Federal Highway Administration

Refer to: HNG-14

Thank you for your letter of January 22 to Mr. James H. Hatton in which you requested Federal Highway Administration (FHWA) acceptance of a revision to your company's PFI 200-1 breakaway coupler for use with luminaire supports. Your letter included drawings of the currently acceptable version of the PFI 200-1 (accepted via our letter of January 26, 1990) and the proposed version as modified (shown on drawing SK 965, revision 01, copy enclosed).

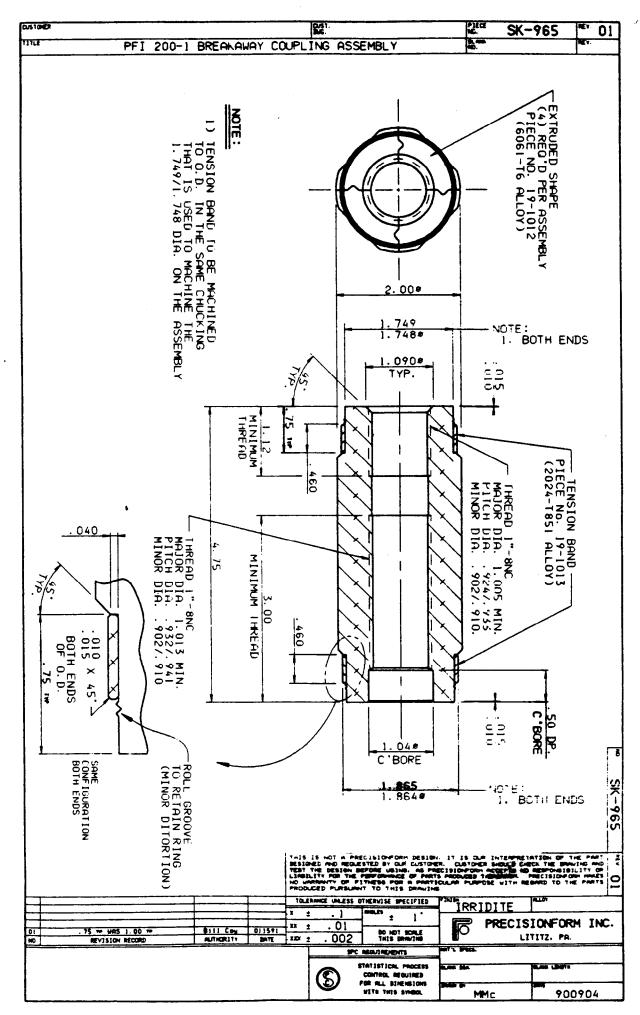
The revisions include increasing the length of the threaded interior of the coupler by 0.50 inches and moving the retaining bands in 0.29 inches from each The data you presented indicate these changes result in increasing the compressive strength of the coupler while not adversely affecting its tensile or shear strengths. The laboratory shear test data included with your letter and in a facsimile message of January 29 indicate that the shear strengths of the prototype modified PFI 200-1 (drawing number SK-965, revision 01) fall within the same range as the results recorded during testing of your current production model. Only four shear tests on the modified PFI 200-1 (SK 965 revision 01) were conducted. Therefore, we are granting acceptance of the modified device contingent upon your providing us data on shear tests of early production samples as soon as they are available and that these tests show results similar to those of the replaced coupler. We infer that you have continuously sampled your coupler production to ensure the strength and breakaway requirements of the couplers are met and that you will continue to do so.

The other acceptance conditions in our prior letter, including maximum pole weight (800 pounds) and proprietary restrictions, remain in effect.
